# CITY OF ALBUQUERQUE

**RE: 4023 Silvery Minnow Place NW**  
**Grading and Drainage Plan**  
**Stamp Date: 06/11/18**  
**Hydrology File: G11D014D6**

CANDELARIA - ZENTELLA- GRADING & DRAINAGE PLAN

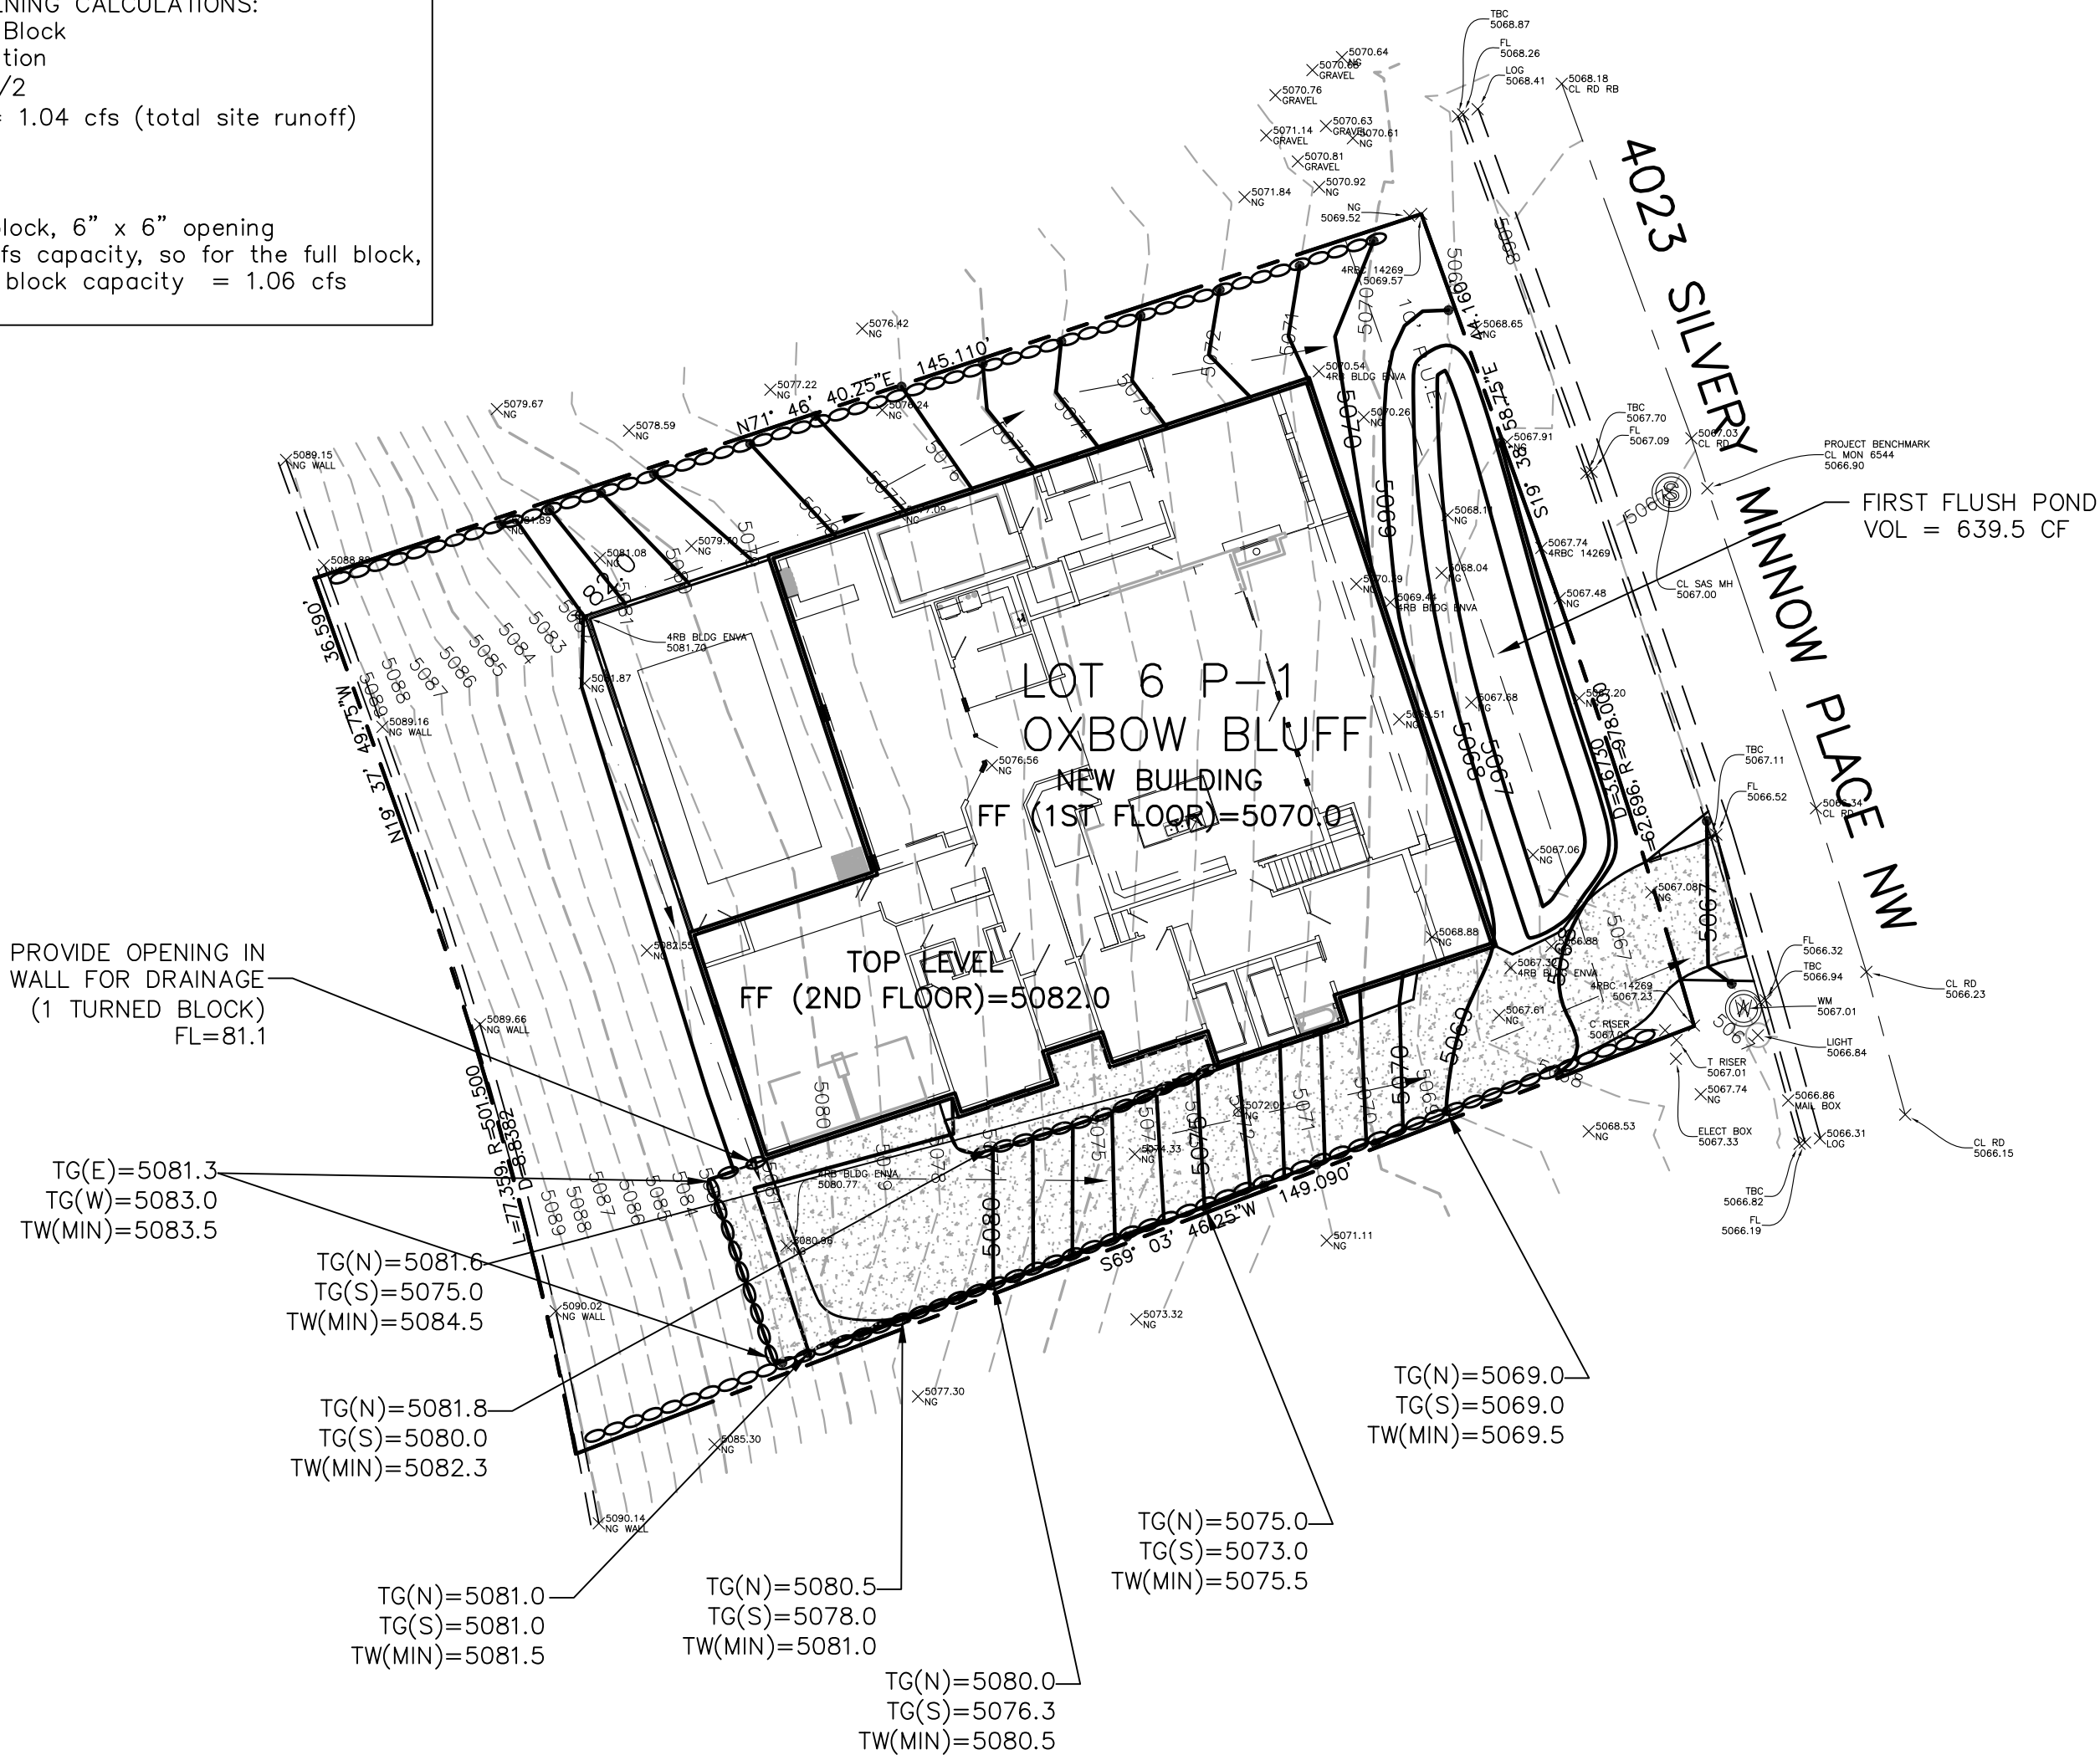
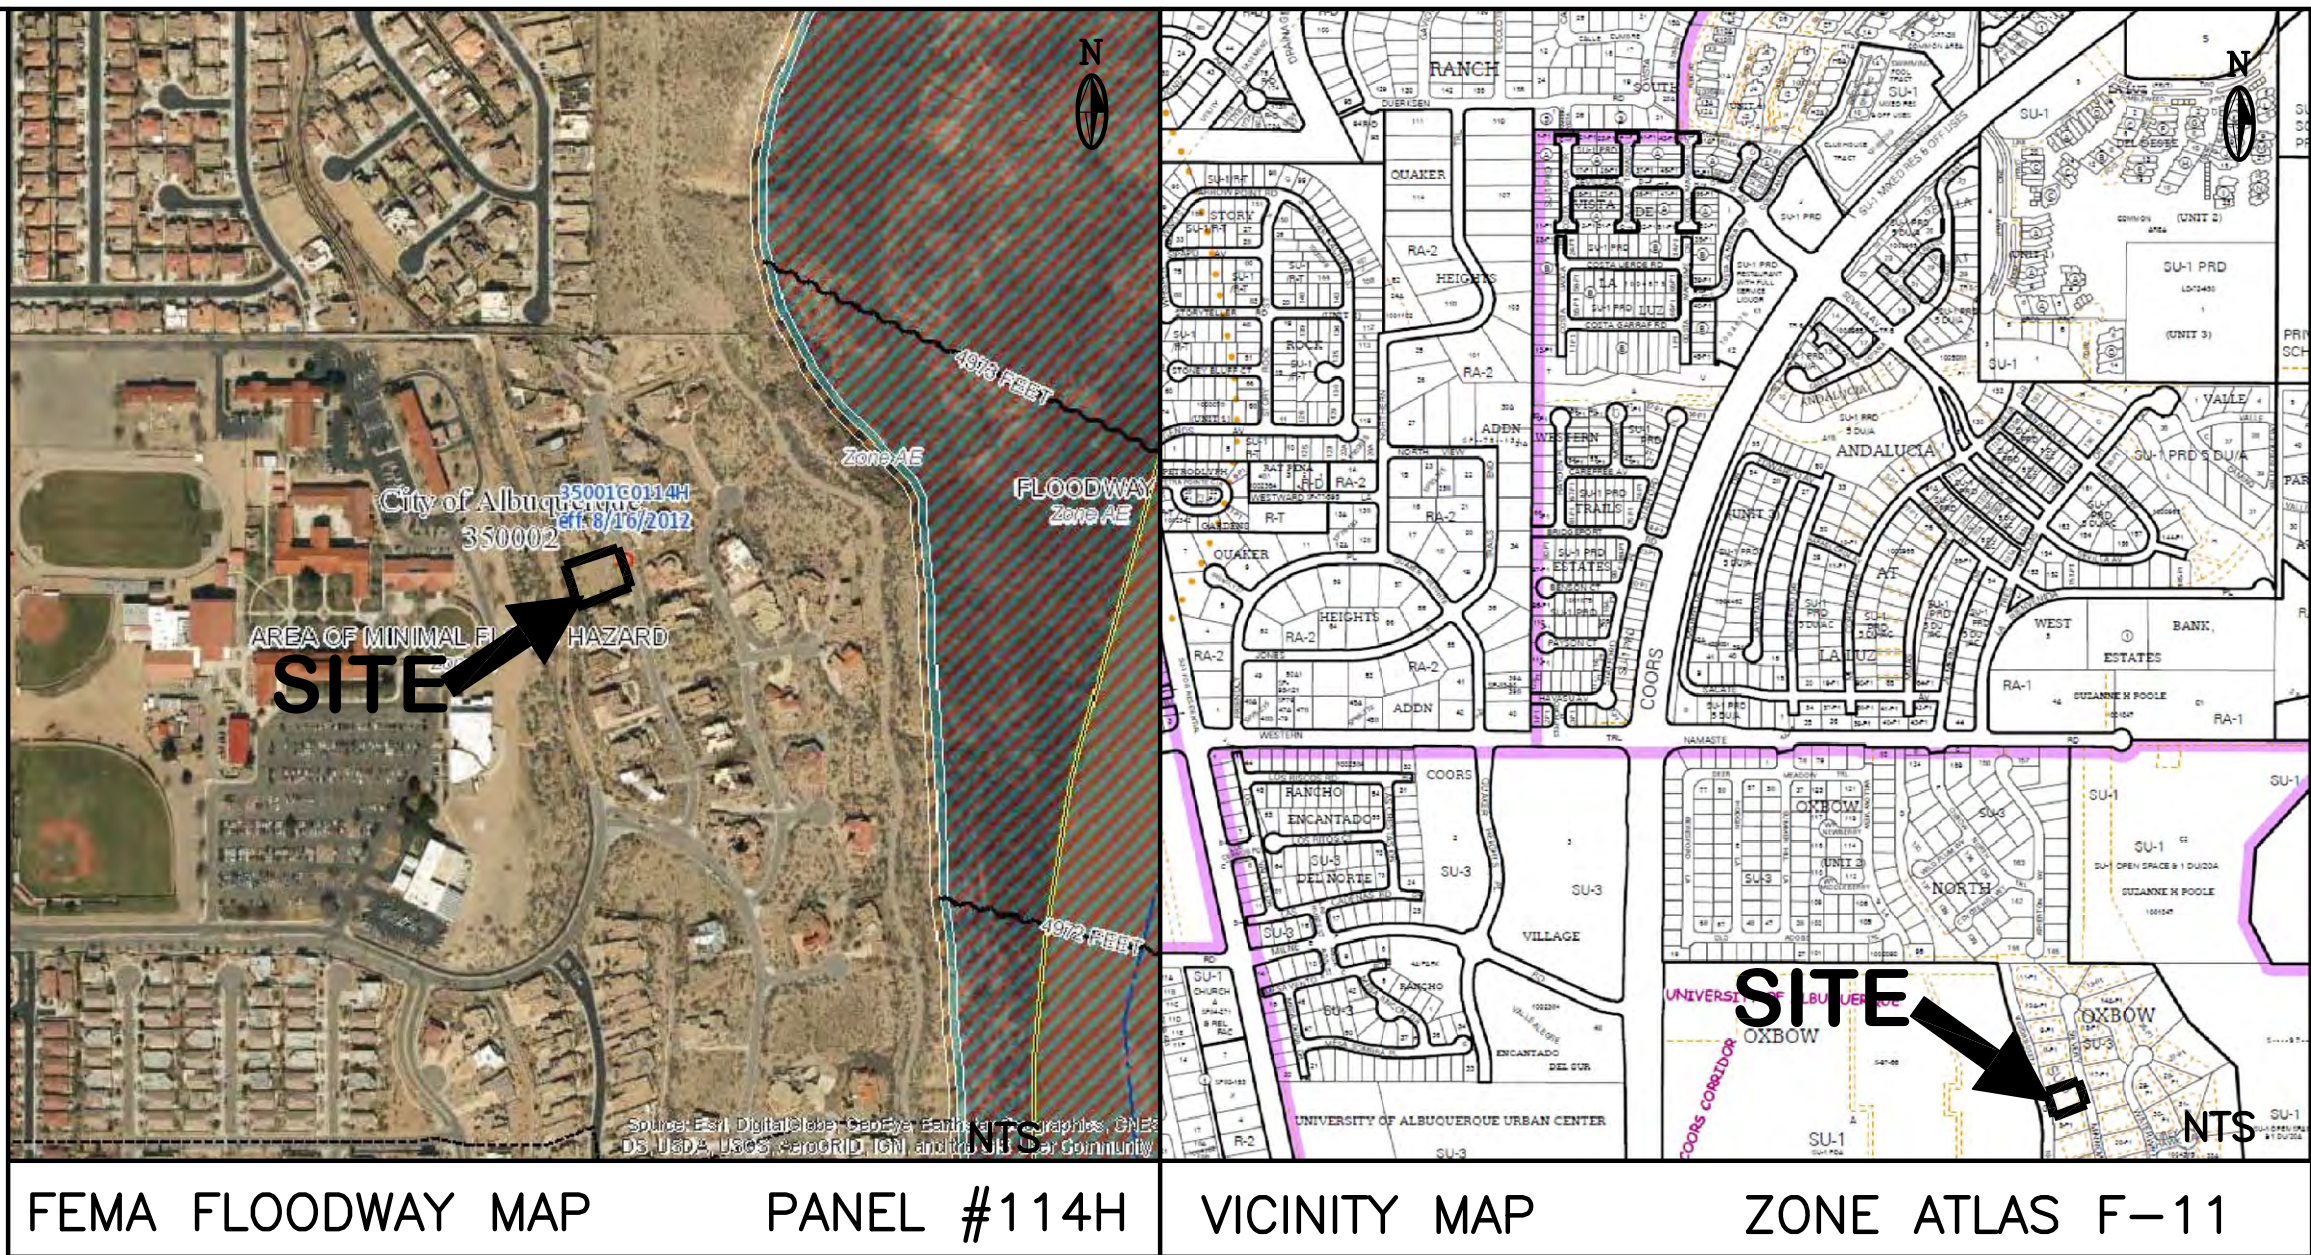
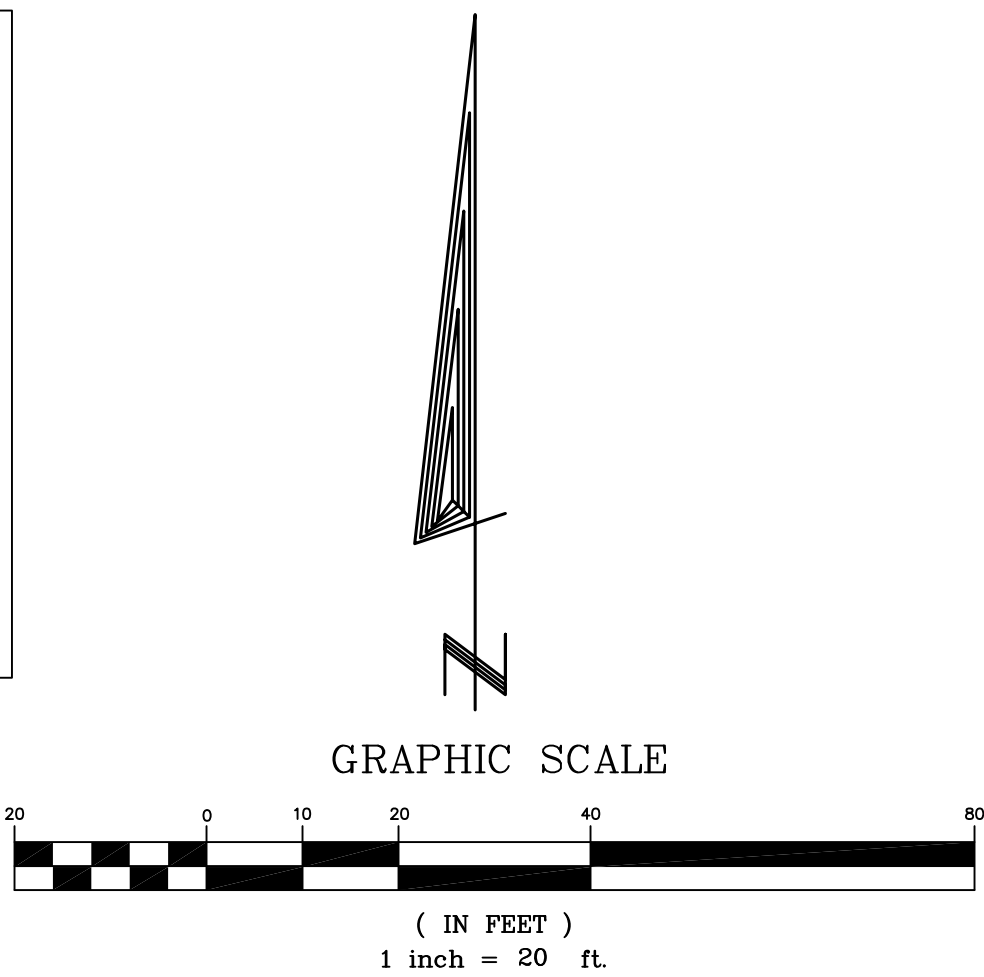
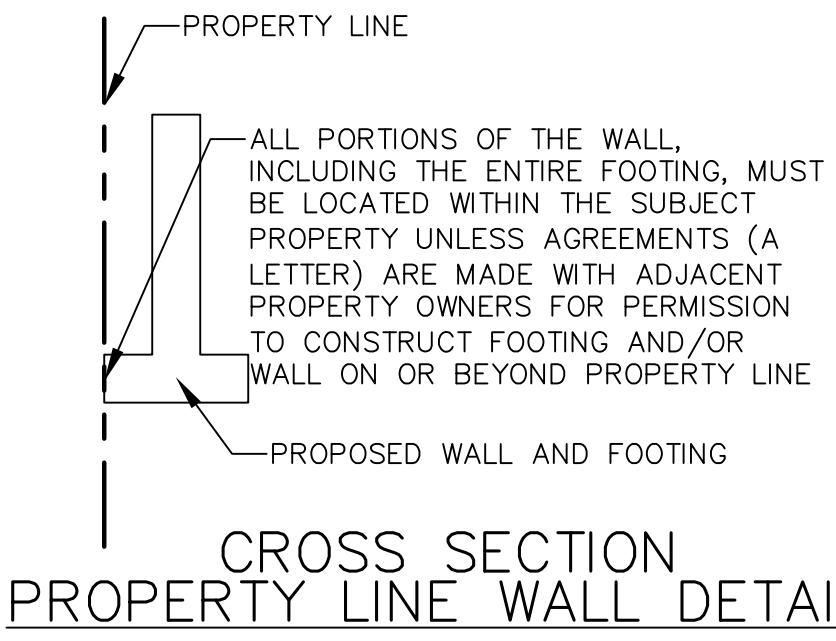
Based upon the information provided in your submittal received 06/19/2018, the Grading Plan is approved for Building Permit.

Once the grading is complete, a pad certification will be required prior to release of Building Permit. Please attach a copy of this approved plan in the construction sets for Building Permit processing.

Prior to approval in support of Permanent Release of Occupancy by Hydrology, Engineer Certification per the DPM checklist will be required and a formal Elevation Certificate needs to be submitted to Hydrology.

Please provide a Private Facility Drainage Covenant per Chapter 17 of the DPM for first flush pond prior to Permanent Release of Occupancy. Please submit this on the 4th floor of Plaza de Sol. A \$25 fee will be required.
